Subject: Interstate 4 from East of SR 15/600 (US 17/92) to ½ Mile East of SR 472 Value Engineering Study Recommendation Dispositions

FM: 408464-2

Interstate 4 from East of State Road 15/600 (US 17/92) to 1/2 Mile East of State Road 472

Value Engineering Study **Draft** Report

RECOMMENDATION No. 17: Construct Rhode Island Avenue with wide median and future construction to the inside instead of to the outside.

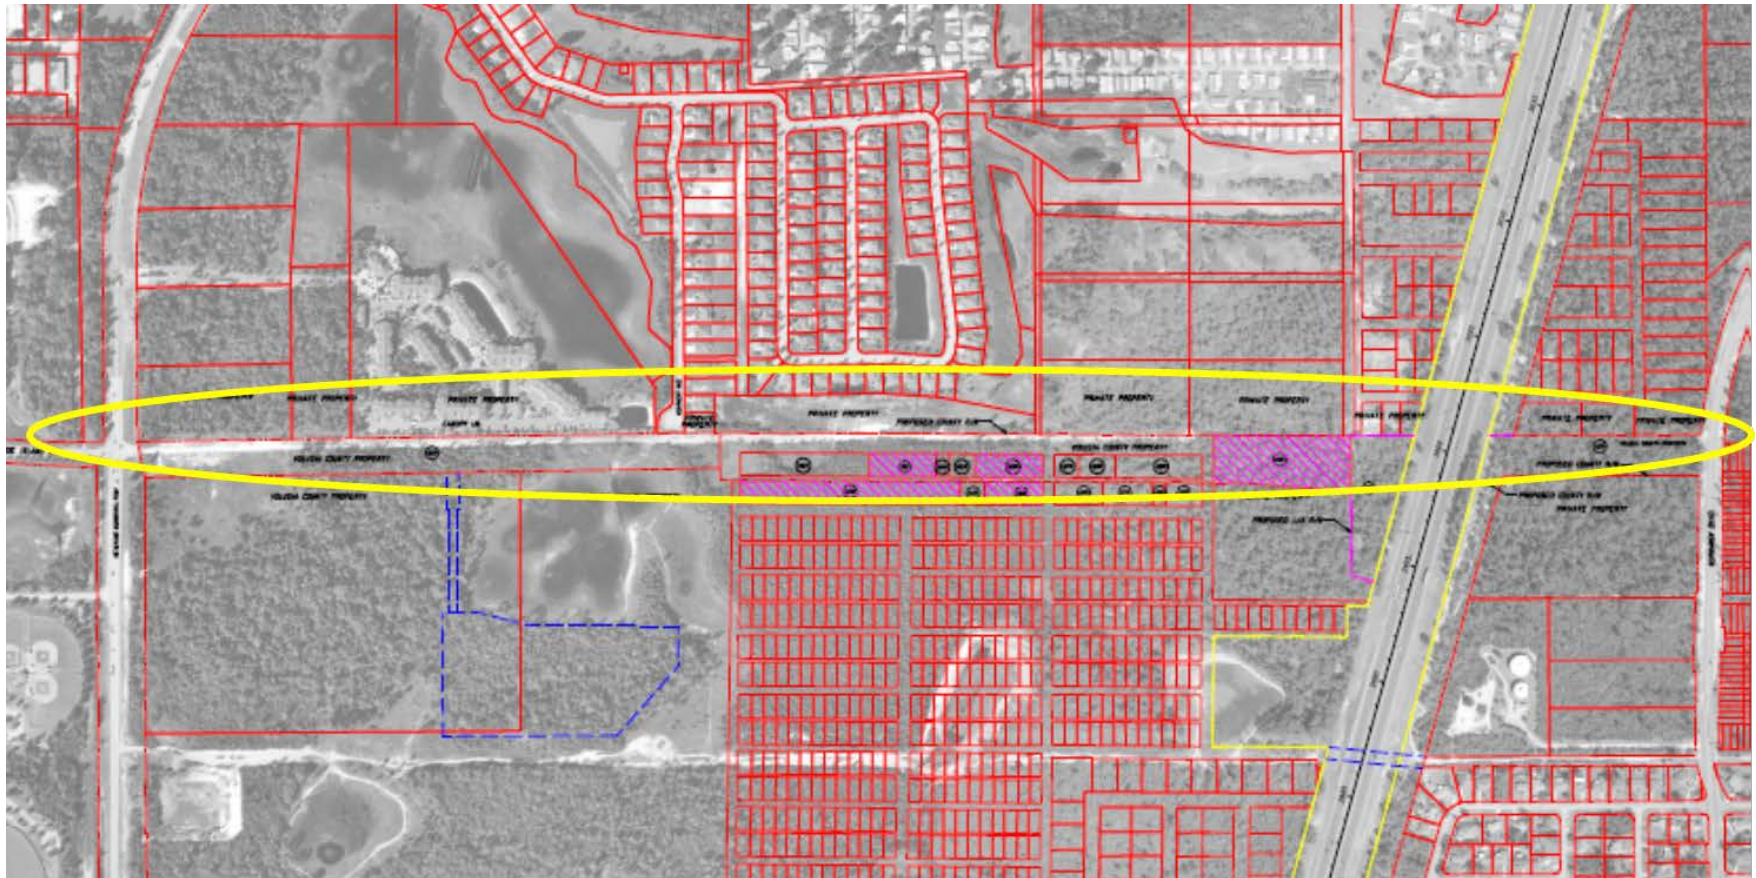
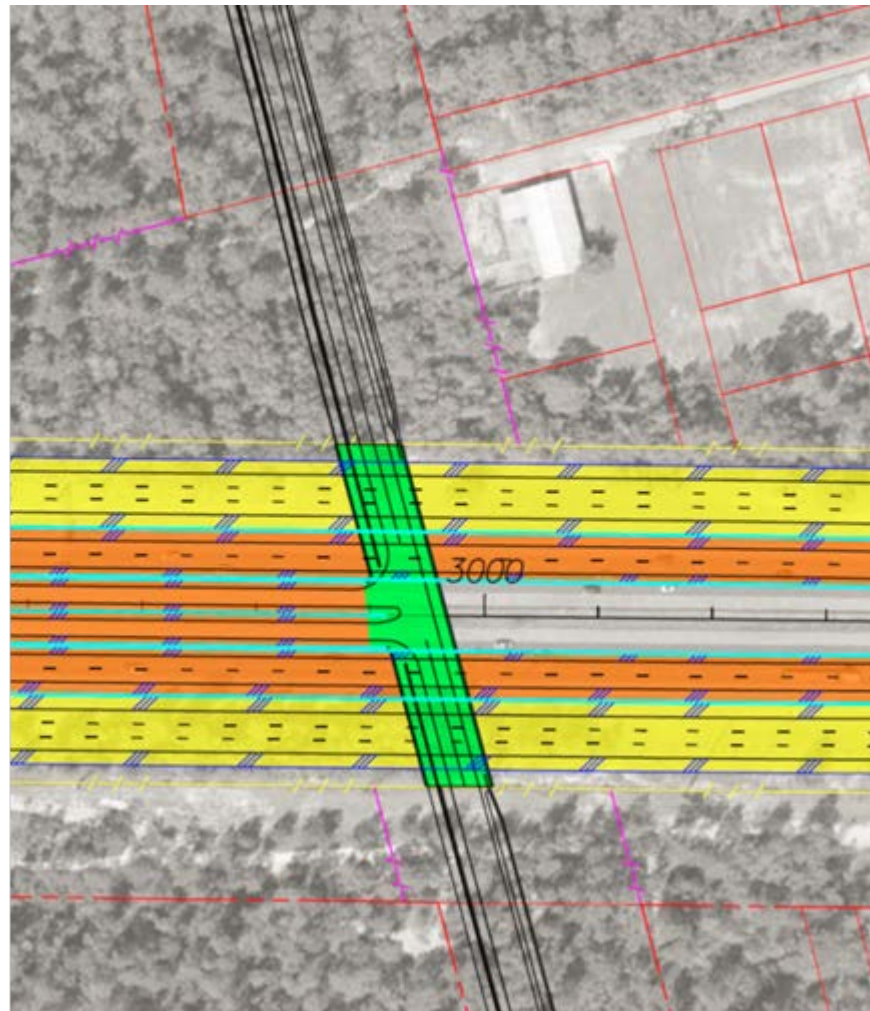
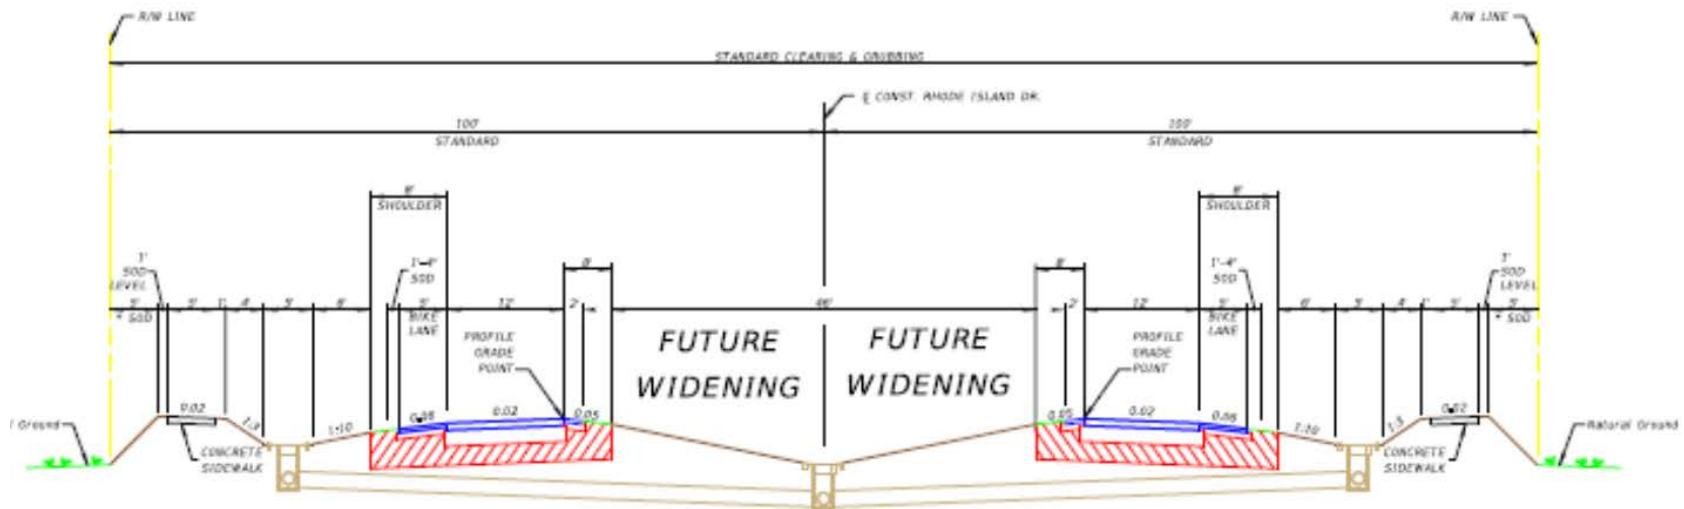
The PD&E Documents show the Volusia County concept plans for Rhode Island Avenue. The County typical for Rhode Island Avenue shows constructing the median, one through lane in each direction with sidewalks and drainage swale between the shoulder and sidewalk. The length of the Rhode Island Avenue project is approximately 1.415 miles.

- Less cost for future widening.
- Less environmental impact for future widening.
- Less impact to the scrub jay habitat that was acquired for Rhode Island Ave.
- Tie-ins for the side street connections will not be impacted in the future widening.

Recommendation 17: Construct Rhode Island Avenue with wide median and future construction to the inside instead of to the outside

Partially Accepted. Because of the length of Rhode Island (approximately 6500-feet) it has been decided to construct the entire roadway at once.

RHODE ISLAND AVE
TO ACCOMODATE FUTURE WIDENING (TO INSIDE)
TO 4 LANE DIVIDED WITH RAISED MEDIAN

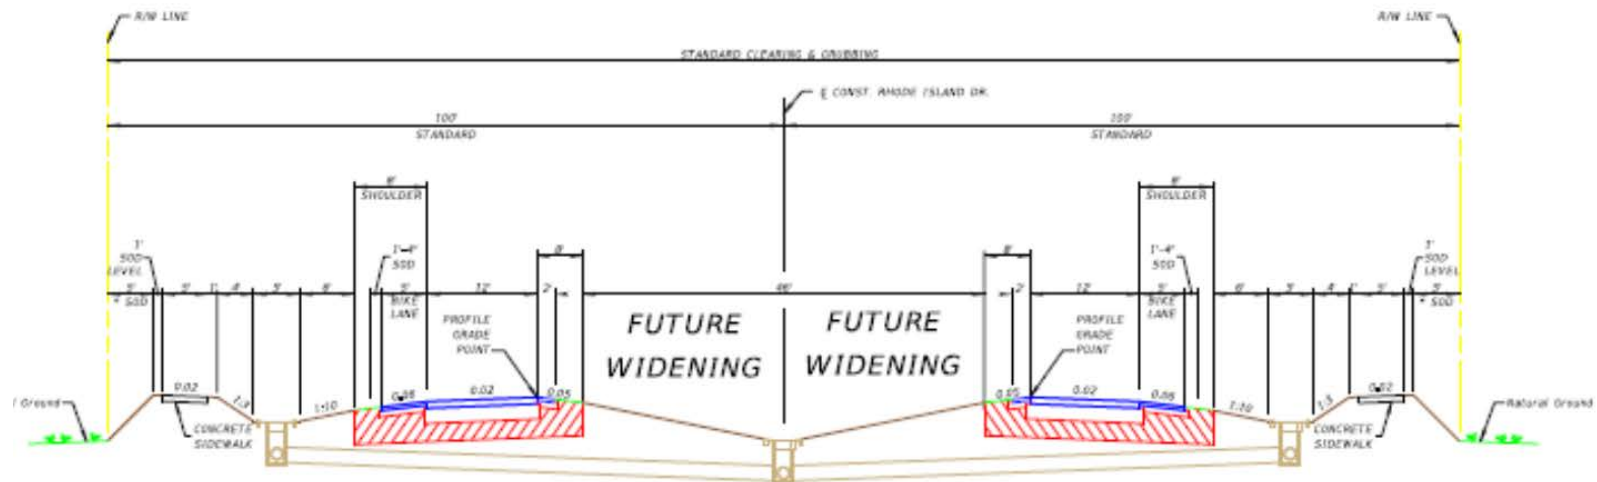
The PD&E Documents show the Volusia County concept plans for Rhode Island Avenue. The County typical for Rhode Island Avenue shows constructing the median, one through lane in each direction with sidewalks and drainage swale between the shoulder and sidewalk.

- Less environmental impact for future widening.
- Less impact to the scrub jay habitat that was acquired for Rhode Island.

- Increased construction cost for the future widening.
- Tie-ins for the side street connections will be impacted in the future widening.

Recommendation 18: Construct Rhode Island Avenue with median and future construction to the north side instead of to the outside

Partially Accepted. Because of the length of Rhode Island (approximately 6500-feet) it has been decided to construct the entire roadway at once.

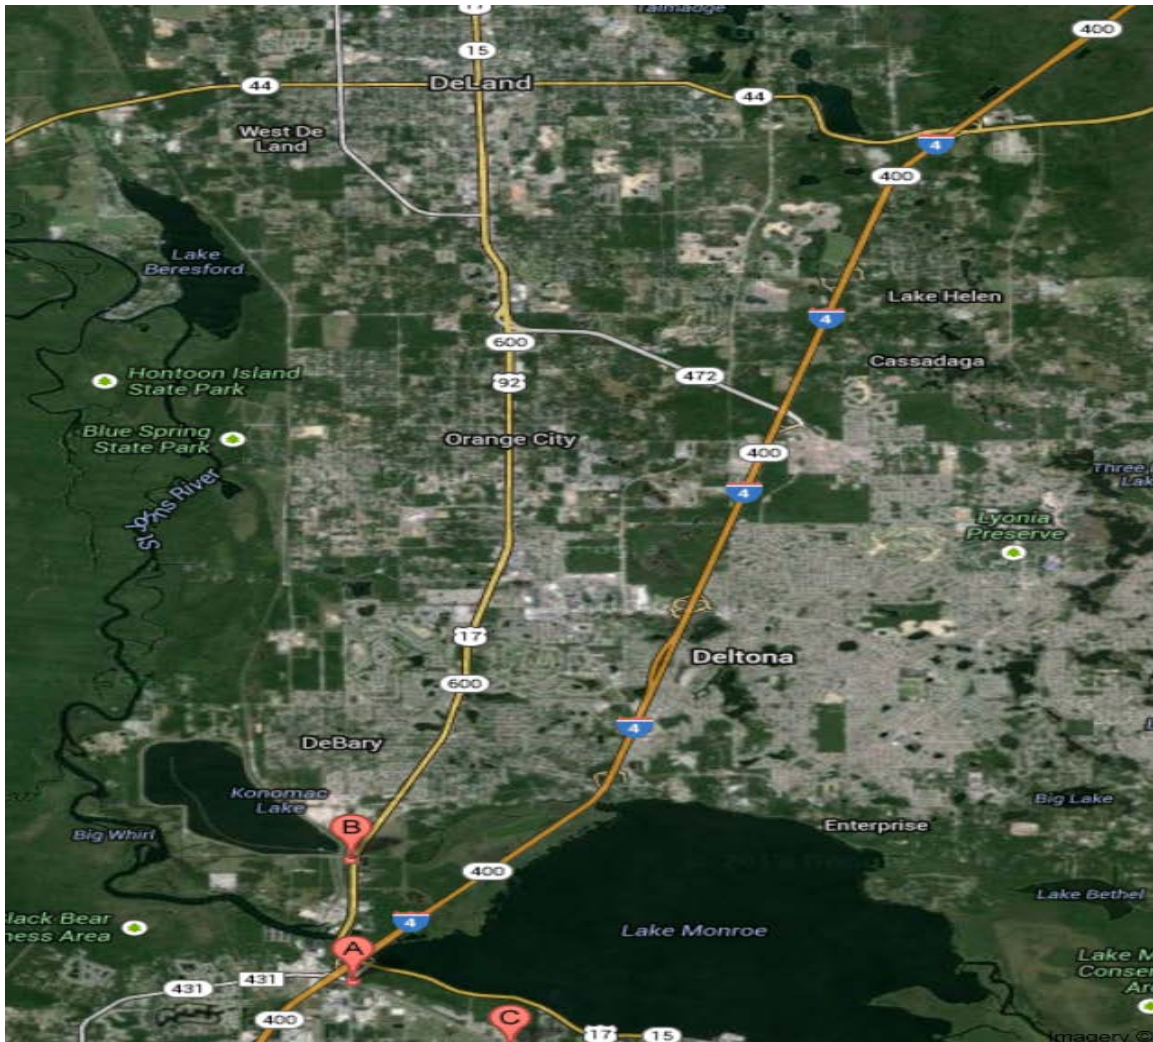
The PD&E Documents show a 44-ft. transit envelope located in the proposed 64-ft. median.

Description	Quantity	Unit	Unit Price	Extended Amount
Barrier Wall	-53,328	LF	\$113.00	(\$6,026,064)
6 Bridges with reduced spans	-1	LS	\$9,000,000.00	(\$9,000,000)
Existing Sound Barrier to remain	-1	LS	\$3,249,000.00	(\$3,249,000)
Subtotal				(\$18,275,064)
Compensable Utility Relocation (5%)	1	LS		(\$913,753)
Mobilization (10%)	1	LS		(\$1,827,506)
Maintenance of Traffic (20%)	1	LS		(\$3,655,013)
Lighting (5%)	1	LS		(\$913,753)
Signage (5%)	1	LS		(\$913,753)
Drainage (20%)	1	LS		(\$3,655,013)
ITS (5%)	1	LS		(\$913,753)
Erosion Control (1%)	1	LS		(\$182,751)
Subtotal				(\$31,250,359)
Contingency (20%)		LS		(\$6,250,072)
		CONSTRUCTION TOTAL		(\$37,500,431)

Recommendation 20: Eliminate the transit corridor and recommend the next segment to the north includes the transit envelope

Not Accepted. At the request of Volusia County, the I-4 envelope must contain a transit corridor.

RECOMMENDATION No. 22: Leave the transit corridor south of SR 472 and recommend using SR 472 to the west to terminate at a transit station that connects with SunRail

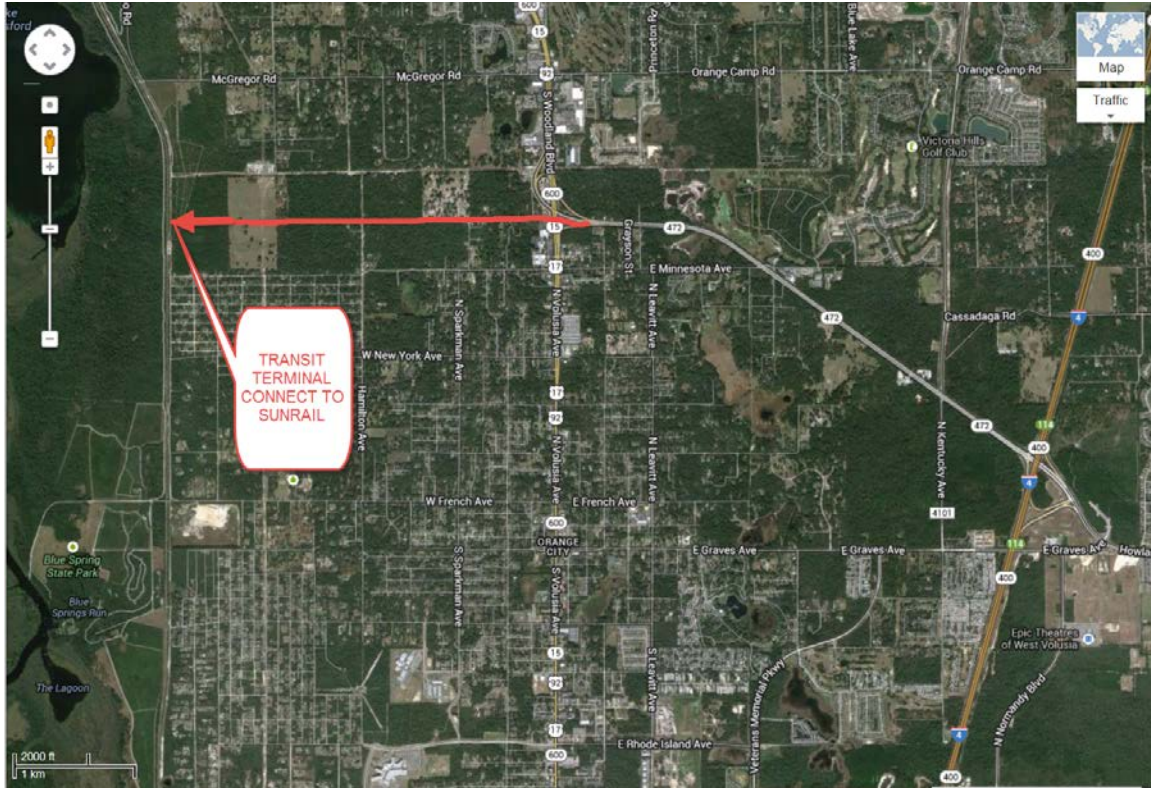
Leave the transit corridor as proposed along I-4 within these project limits and recommend accommodating the transit envelope along SR 472 median to the west to terminate at a transit station that connects with SunRail. The transit corridor along SR 472 will connect to the currently preserved envelope from I-95 to SunRail and provide the required transit corridor running through Volusia County from the south to the Daytona Beach Area.

The transit corridor along SR 472 can be considered and planned as part of the future improvements along SR 472 and adjacent intersections. According to the FDOT work program and 2035 adopted River to Sea Transportation Planning Organization’s Long Range Transportation Plan, so far there are planned and programmed future improvements as shown on the following table:

Recommendation 22: Leave the transit corridor south of SR 472 but consider using SR 472 to the west to terminate at a transit station that connects with SunRail

Accepted. FDOT is committed to maintaining sufficient room along the SR 472 corridor until such time that a final decision has been reached as to where rail will be located in Volusia County.

RECOMMENDATION No. 24: Use Alternative 1 Interchange with an additional eastbound off ramp auxiliary lane to connect directly to Normandy Boulevard intersection

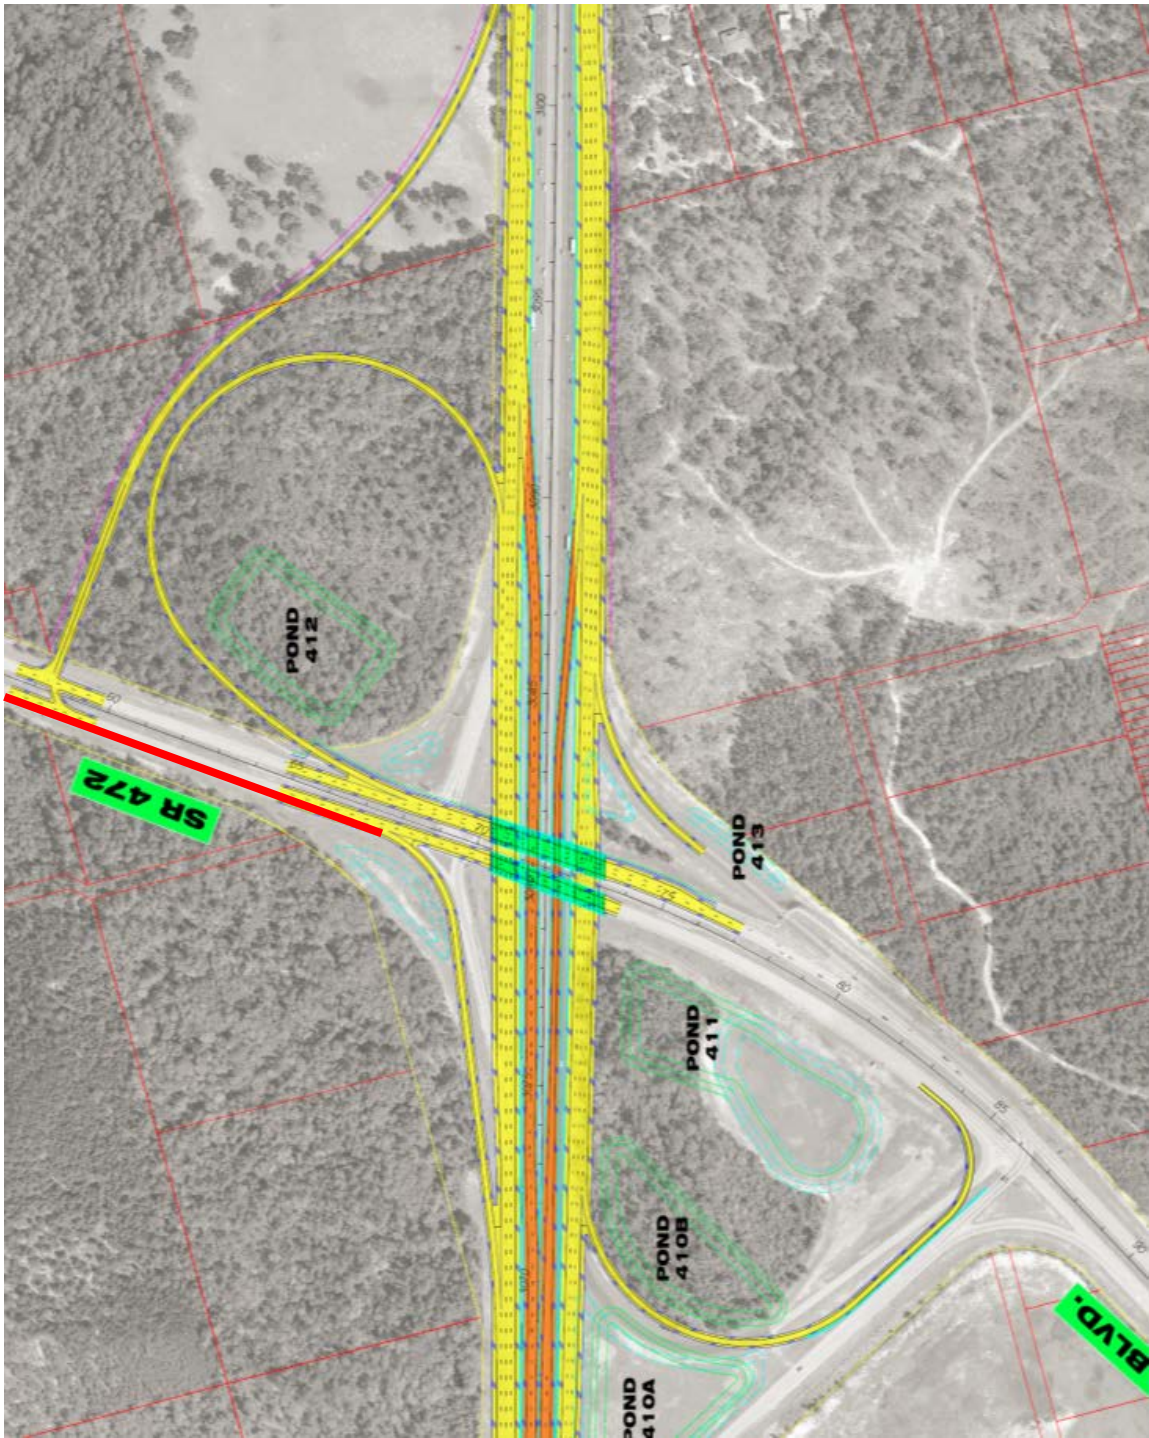
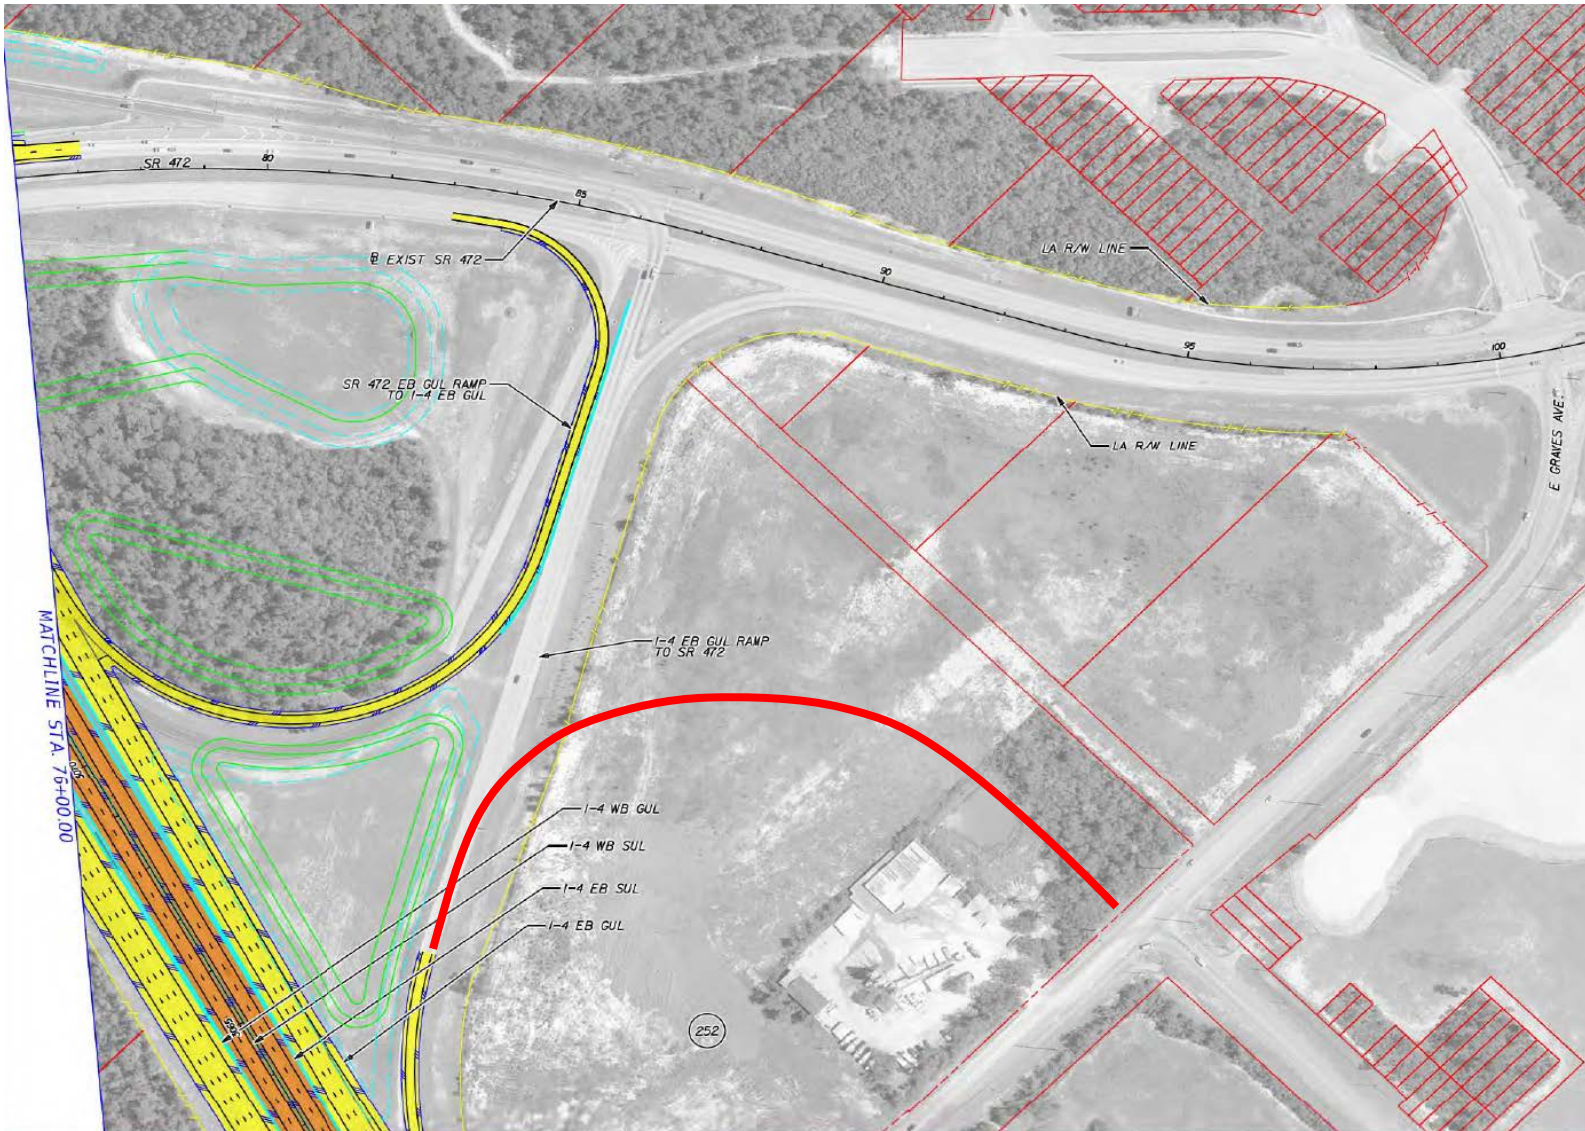
The PD&E Documents show a partial cloverleaf interchange with loop ramps in the northwest and southeast quadrants. The existing single lane I-4 eastbound off ramp will continue to connect from the I-4 general use lanes to SR 472. The existing single lane loop on ramp will continue to connect eastbound SR 472 to the I-4 eastbound general use lanes. The existing single lane on ramp will continue to connect westbound SR 472 to the I-4 eastbound general use lanes. A new single lane off ramp will be constructed to provide access from the I-4 westbound general use lanes to SR 472. A new single lane loop ramp will be constructed to provide access from westbound SR 472 to the I-4 westbound general use lanes. A new single lane ramp will be constructed to provide access from SR 472 eastbound to the I-4 westbound general use lanes. Pedestrian access will be maintained along the northern side of SR 472 and an additional sidewalk will be added to the south side of the eastbound bridge. Additional right of way will need to be purchased in order to construct the new loop ramp and the new off ramp from the westbound general use lanes. Additional right of way will also be needed to build the new on ramp from westbound SR 472 to the I-4 eastbound general use lanes.

- Increased cost associated with added ramp lane to Normandy Boulevard and extension of I-4 westbound on ramp lane.
- Requires right of way acquisition for the added I-4 eastbound off ramp lane to Normandy Boulevard.

Recommendation 24: Use Alternative 1 Interchange with an additional eastbound off ramp auxiliary lane to connect directly to Normandy Boulevard intersection

Not Accepted. The additional eastbound off ramp was evaluated and it provides little to no improvement to the interchange from an operations standpoint.
